**TOWN OF NEWBURGH  
PLANNING BOARD  
TECHNICAL REVIEW COMMENTS**

**PROJECT NAME:** JIN KANJANAKIRITUMRONG (2014-08)  
**PROJECT NO.:**  
**PROJECT LOCATION:** SECTION 66, BLOCK 1, LOT 3 ZONE IB  
**REVIEW DATE:** 13 FEBRUARY 2015  
**MEETING DATE:** 19 FEBRUARY 2015  
**REPRESENTATIVE:** VINCENT DOLCE

RE: Site Plan lands of Jin Kanjanakiritumrong  
349 Meadow Avenue  
Town of Newburgh Tax Parcels: Section 66 Block 2 Lot 3  
Town Project No. 2014- 08

**SITE PLAN**  
LANDS OF  
**JIN KANJANAKIRITUMRONG**  
349 MEADOW AVENUE, TOWN OF NEWBURGH  
ORANGE COUNTY, NEW YORK  
DATE: APRIL 29, 2014 SCALE: 1 IN. = 20 FT.

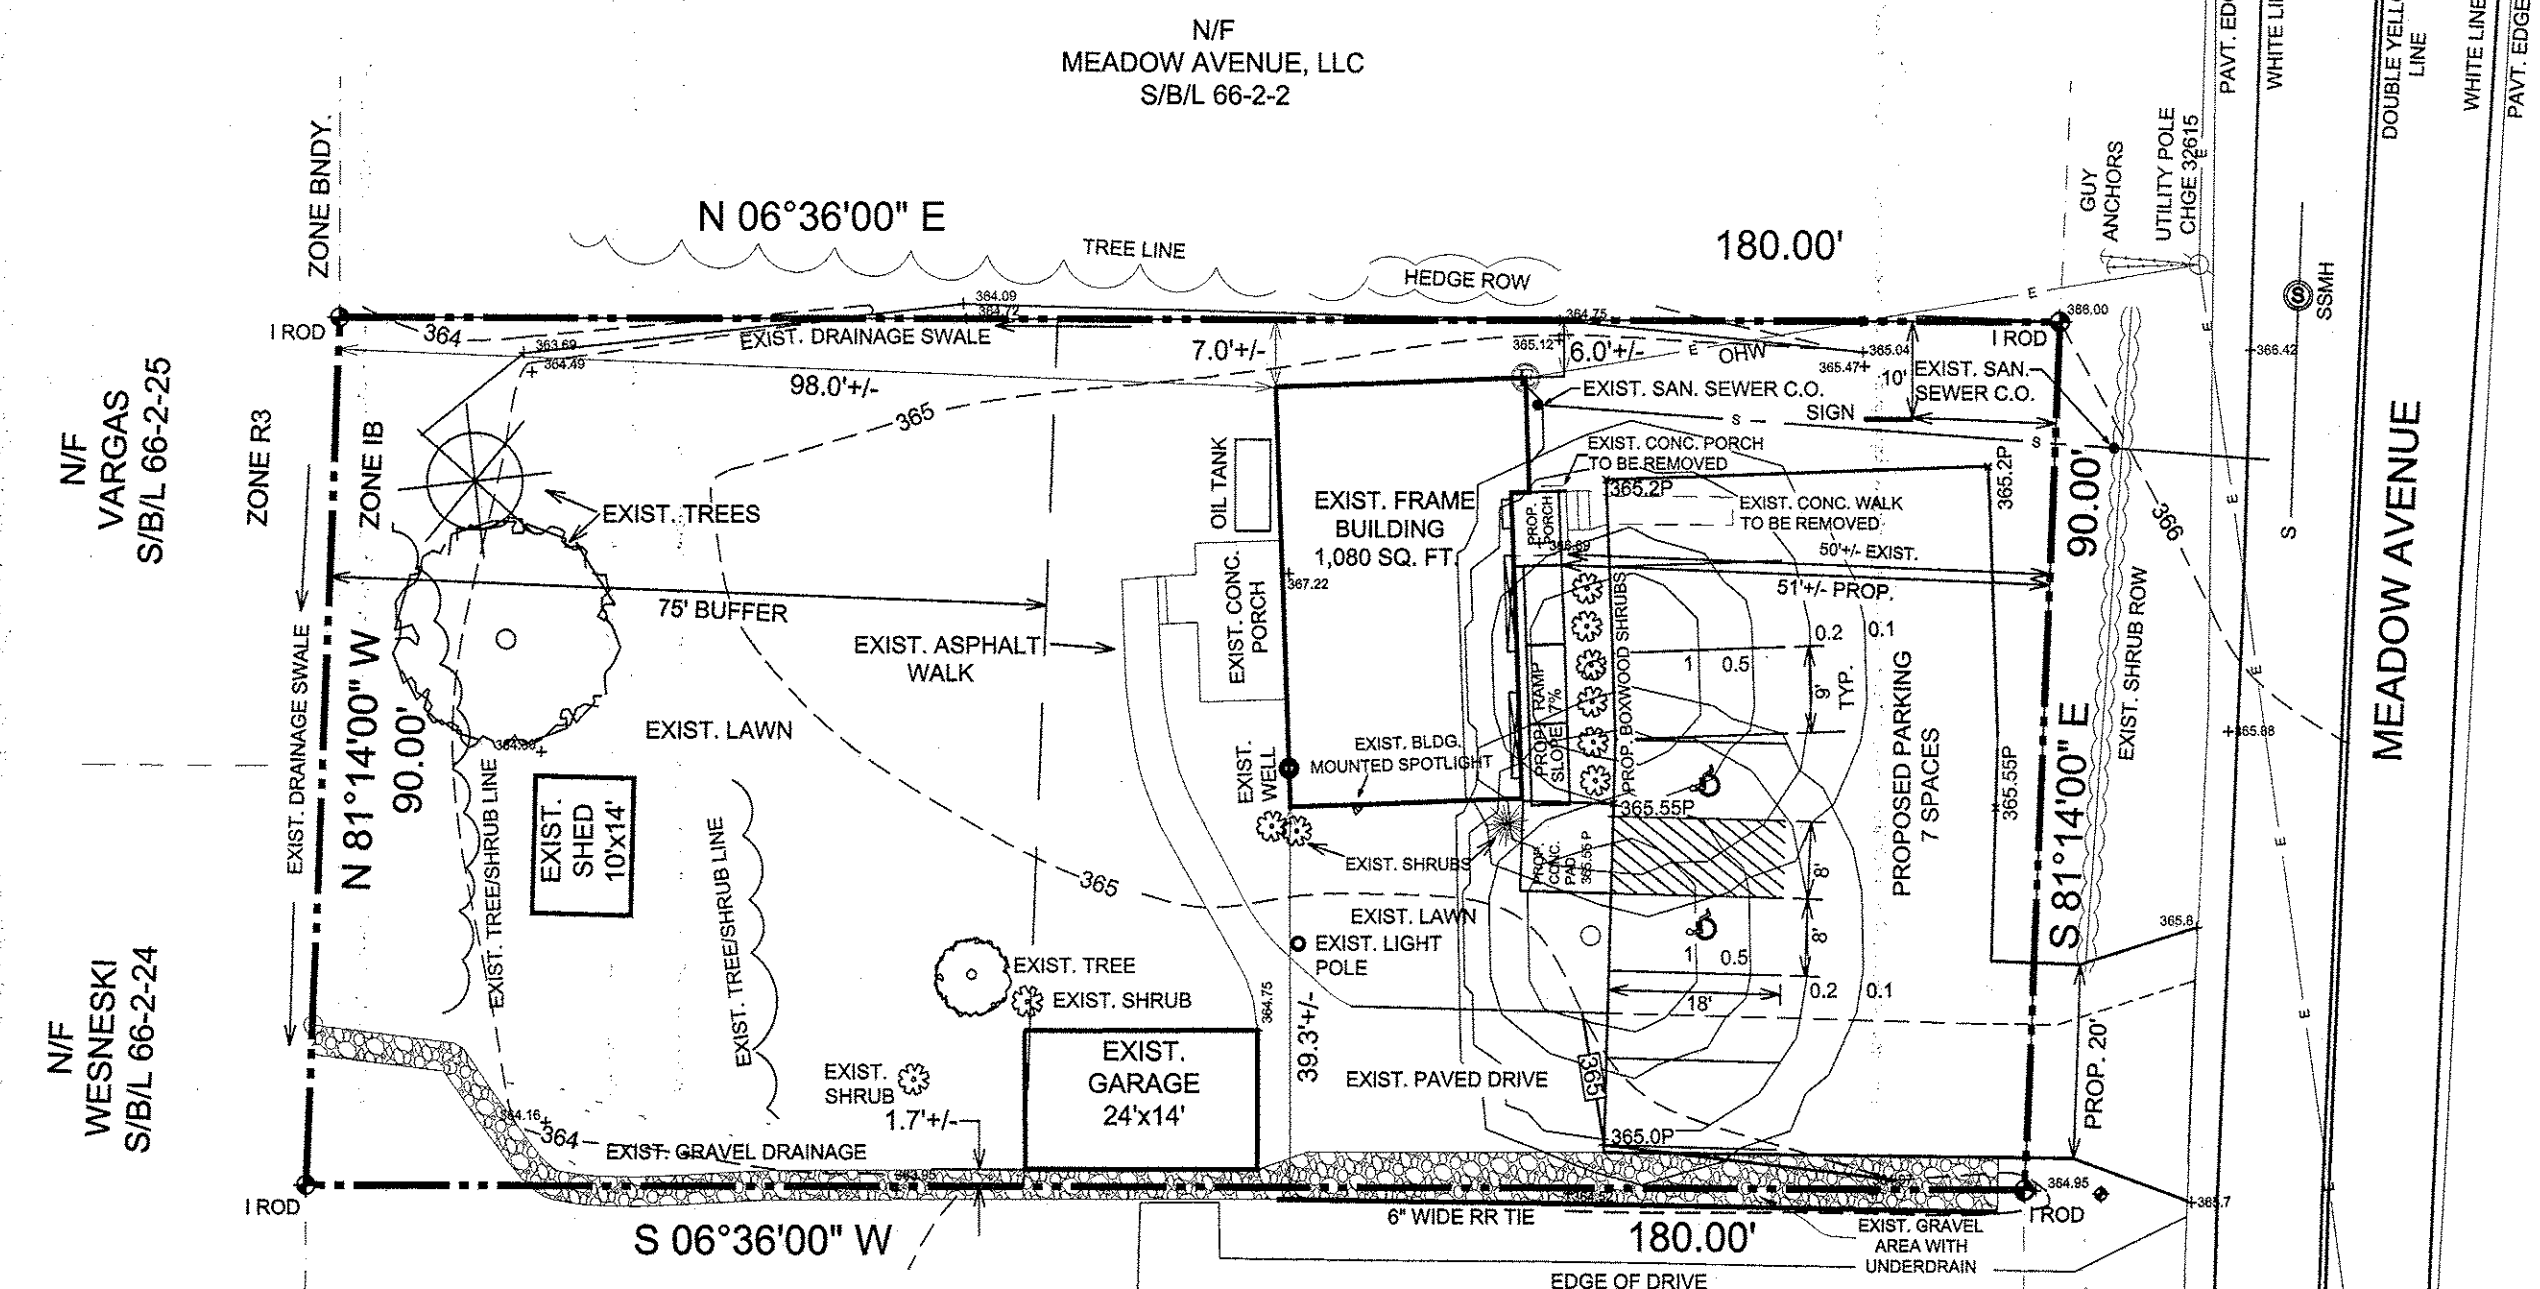
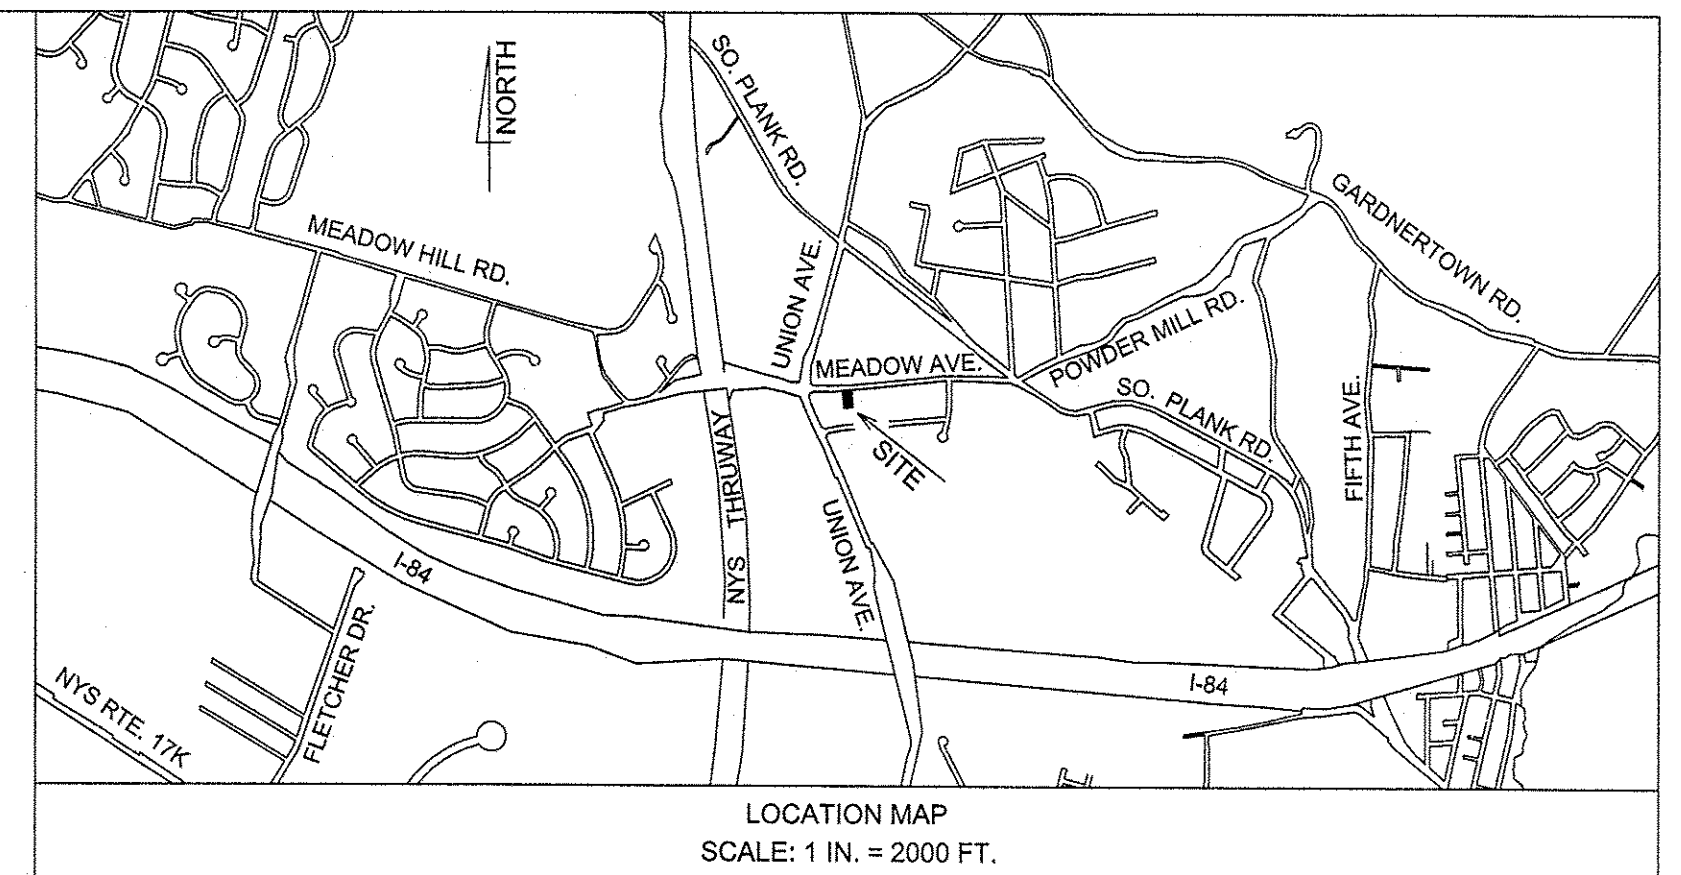
1. Additional runoff from the increase in impervious surfaces should be addressed by the Applicant's representative. Existing gravel drainage swale and discharge location of the same should be addressed in a narrative report.
2. Planning Board should discuss the need for curbs within the proposed parking area.
3. The Applicant's representative were requested to evaluate the need for two ADA accessible parking spaces. Only 7 parking spaces are required if 2 are ADA, it limits the number of open spaces to 5.
4. The Applicant's representative requested a waiver for the design guidelines for parking in front yard. Adjoining land users park in the front yard.
5. Applicant's representative is requested to discuss the use of accessory structures including an existing garage and existing shed on the parcel.
